Petition Number: #2022-123

From: Jake Carpenter, PE Reviewer: Travis Miller

Revision Log:

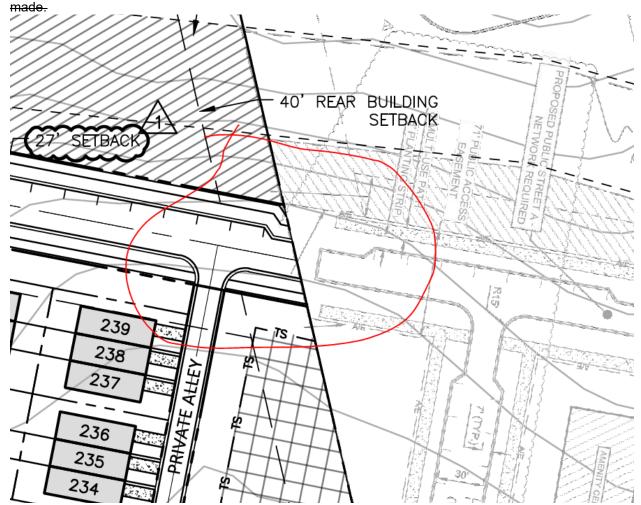
2. Traffic Study:

A Traffic Impact Study (TIS) is not required for the complete review of this petition due to the site generating less than 2,500 daily trips and/or not triggering any other City TIS requirements.

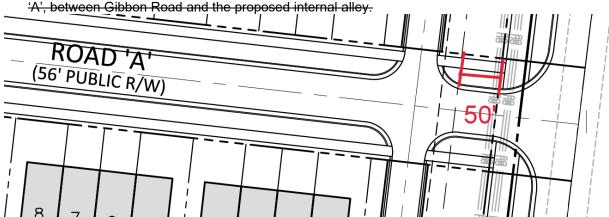
10. Revise site plan to provide a minimum internal stem length of 50' between radius returns along Road
